Project: Ingliston Farm
 Drawing no: ING039
 Drawing by: Bojan Jevtic
 Approved by: Andy Lowe
 OS Licence N°: 100050069

I note that comments from the residents of Easter Denoon have recently been submitted to Angus Council regarding the above application. I feel that the majority of these comments have been addressed in the original application and in the letter to Angus Council dated 7th October. However, there are a number of these observations which may raise unnecessary concern with other nearby residents and as such I would like to provide further clarity.

DRAWING TITLE: Dwellings and ZTV
 DRAWING NO: ING081
 DOCUMENT SIZE: A3
 SCALE: 1:15,000
 DATE: 04/09/2013
 DRAWING BY: Bojan Jevtic
 APPROVED BY: Andy Lowe

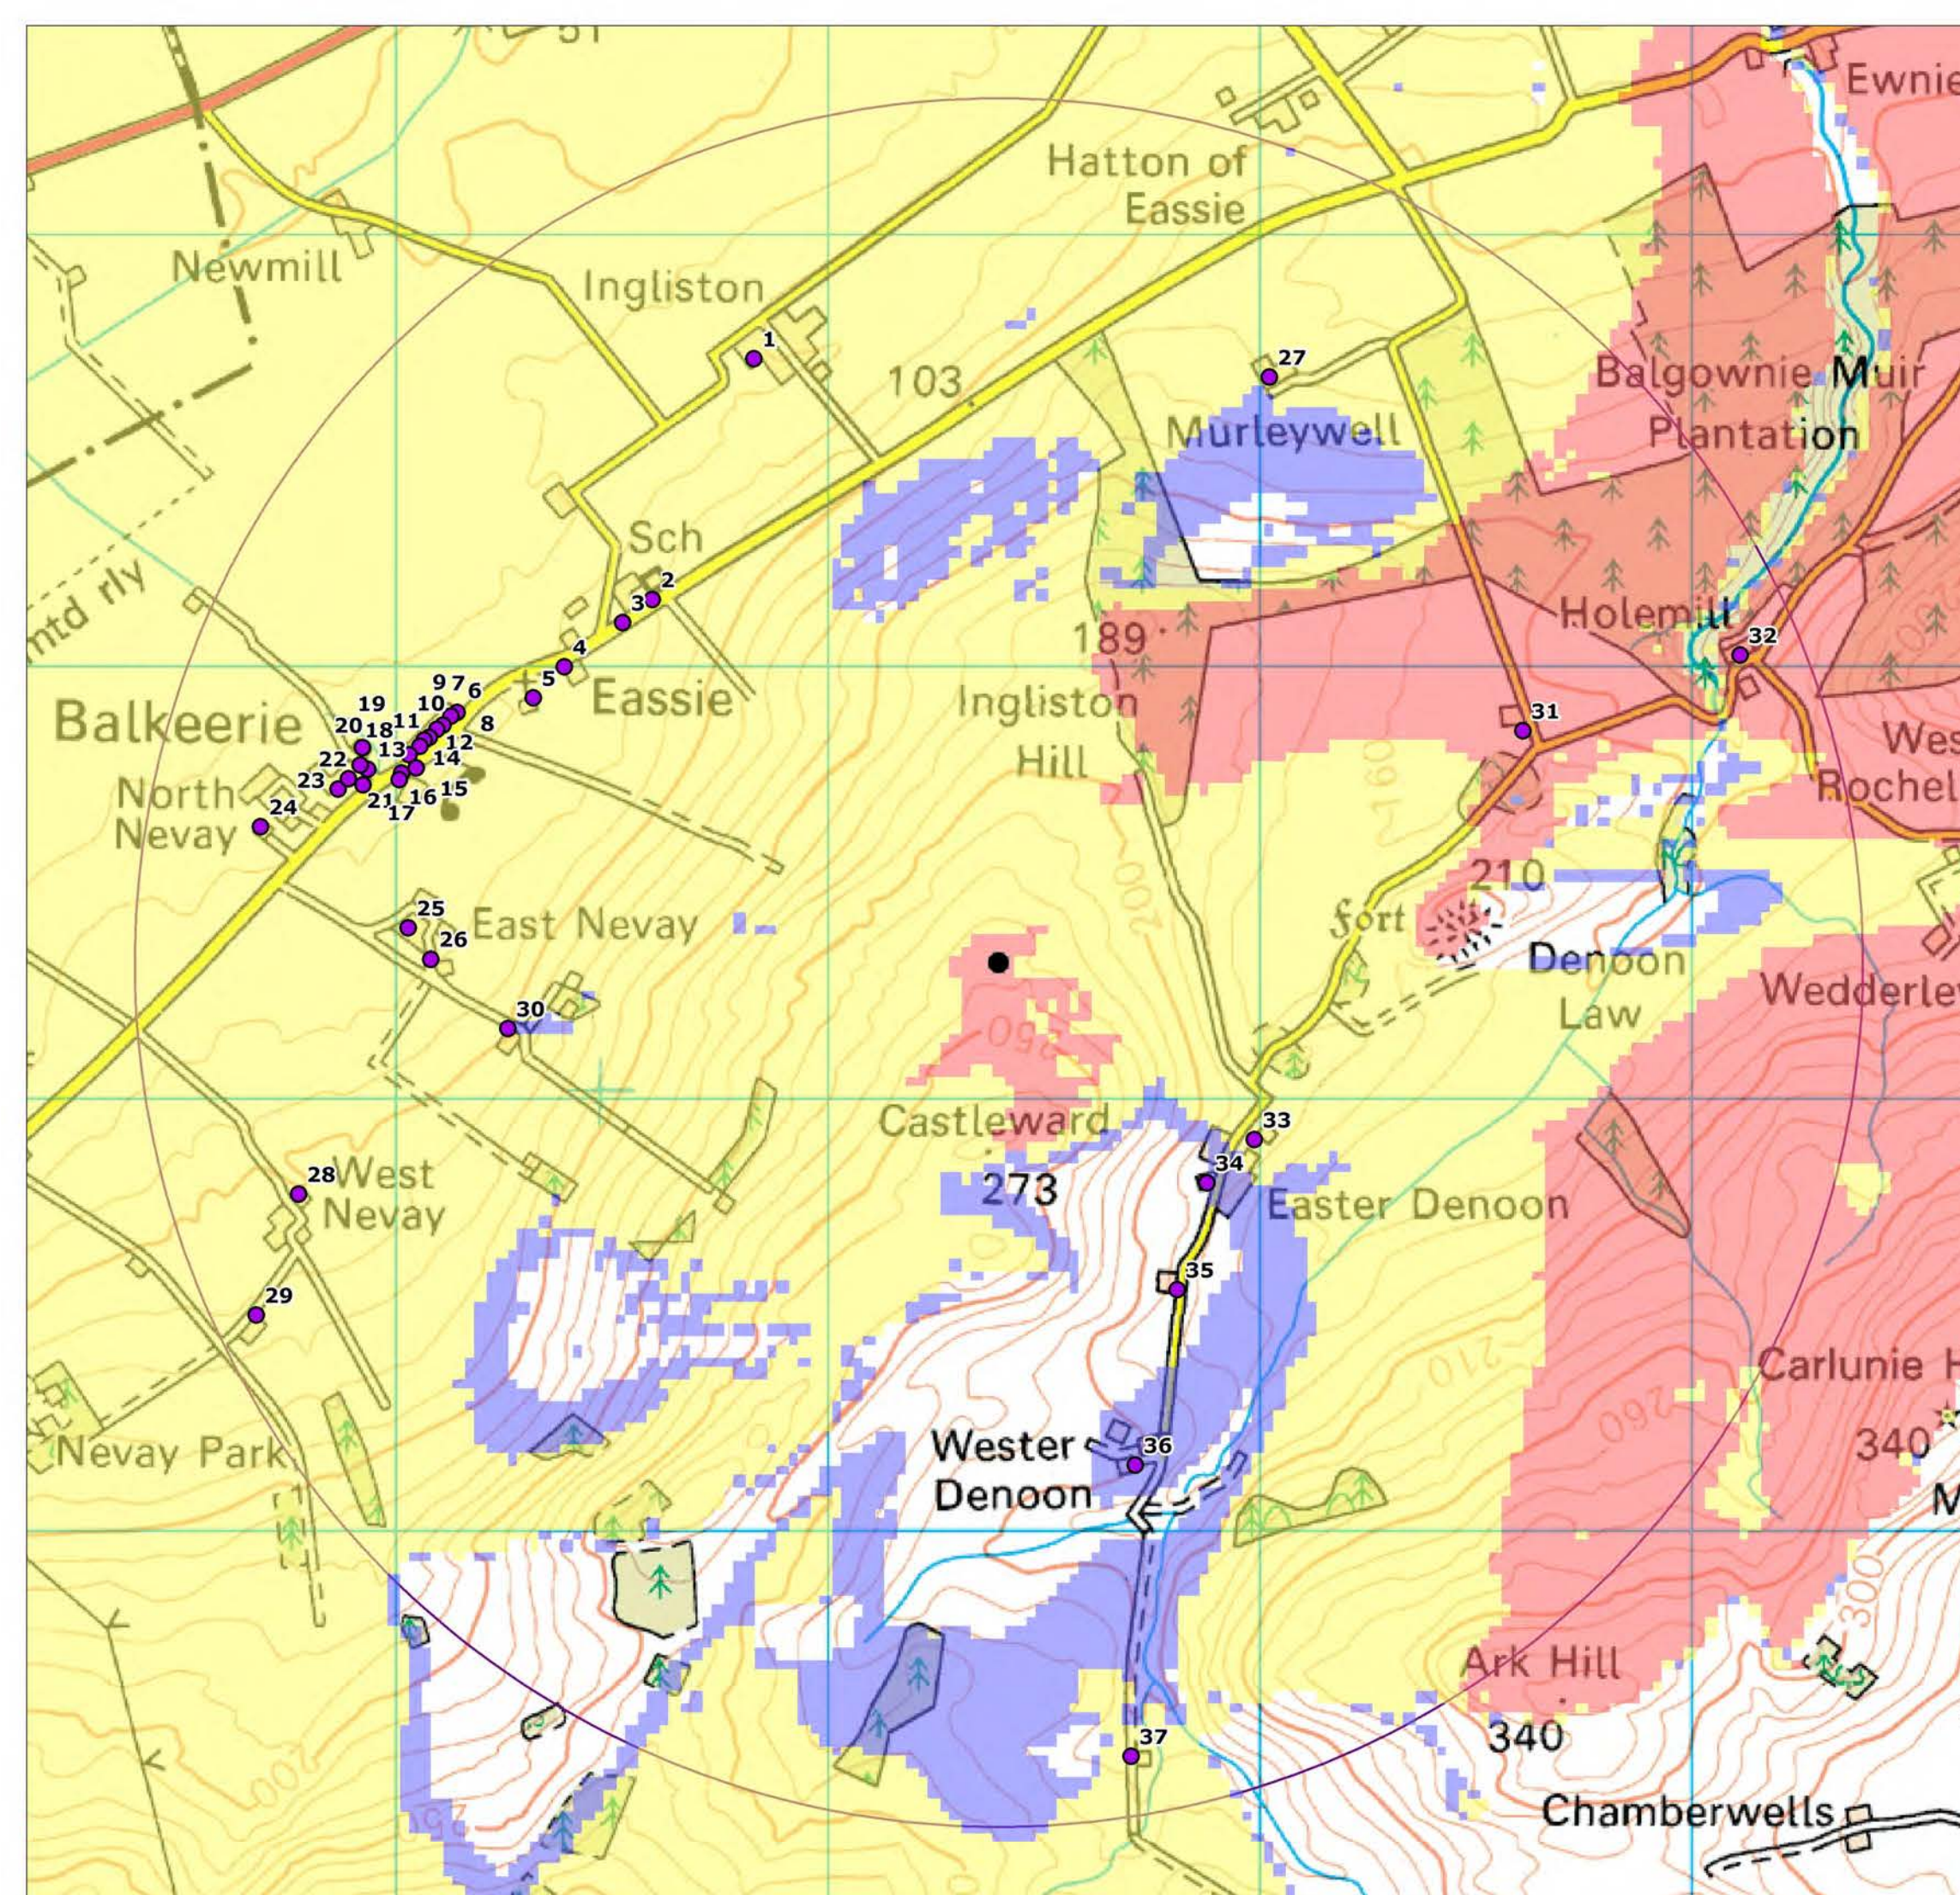
Comment: Scant regard is given to Balkeerie Village and no mention is made of Ingliston Farm Cottages (five properties).

Response: Seven dwellings at Ingliston Farm Cottages and several properties at Belkeerie are included in Table 16 of the Supporting Environmental Document. These can also be seen in Drawings ING081-082.

Figure 1: Predicted cumulative noise model (using ReSoft Windfarm and L_{A90} data)

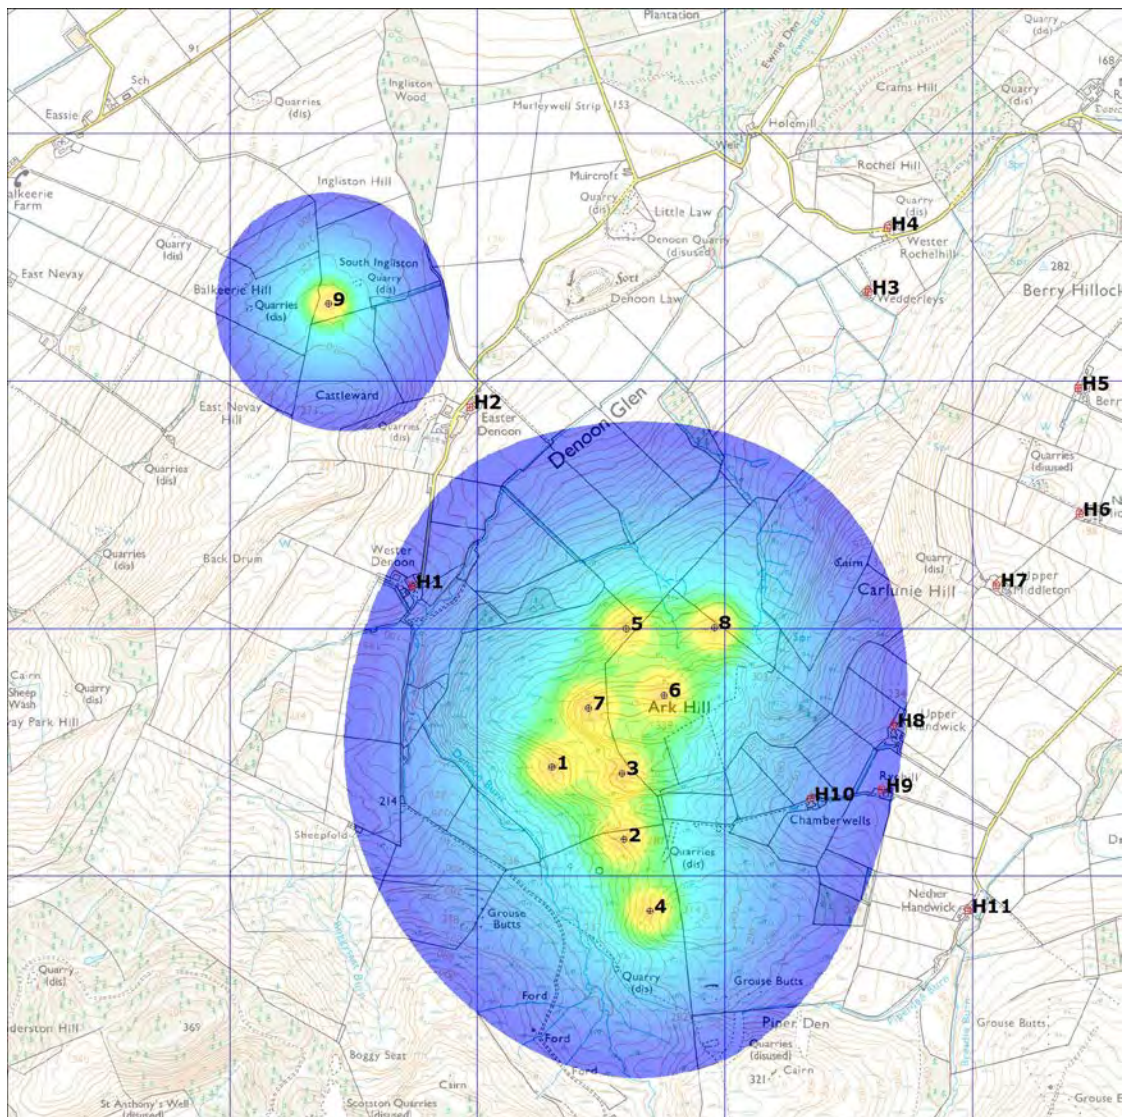
Comment: Noise monitoring/modelling (several bullet points).

Response: Chapter 11 and Appendix C within the Supporting Environmental Document confirm that the limits set by the ETSU-R-97 regulations will not be exceeded at any properties. A Cumulative Noise Assessment has also been recently submitted to Angus Council's Environmental Health Department. This assessment concludes that there will be no significant cumulative noise impact, and that the noise levels at nearby receptors are not predicted to increase above the permitted levels as outlined within the conditions attached to the planning permission for the Ark Hill Wind Farm. It is not considered that any omissions have been made in the submitted Noise Assessments. A circa 700m residential separation distance is relatively large for a single turbine scheme, and our assessments have concluded this will be sufficient to remove the risk of unacceptable noise impact on nearby dwellings.

As can be seen in the tables above, predicted cumulative noise levels at dwellings Chamberwells, Nether Handwick, Wester Denoon, Upper Handwick, Ryehill and Easter Denoon will remain significantly below the criterion limits. These properties are specifically mentioned in the Ark Hill planning condition outlined above.
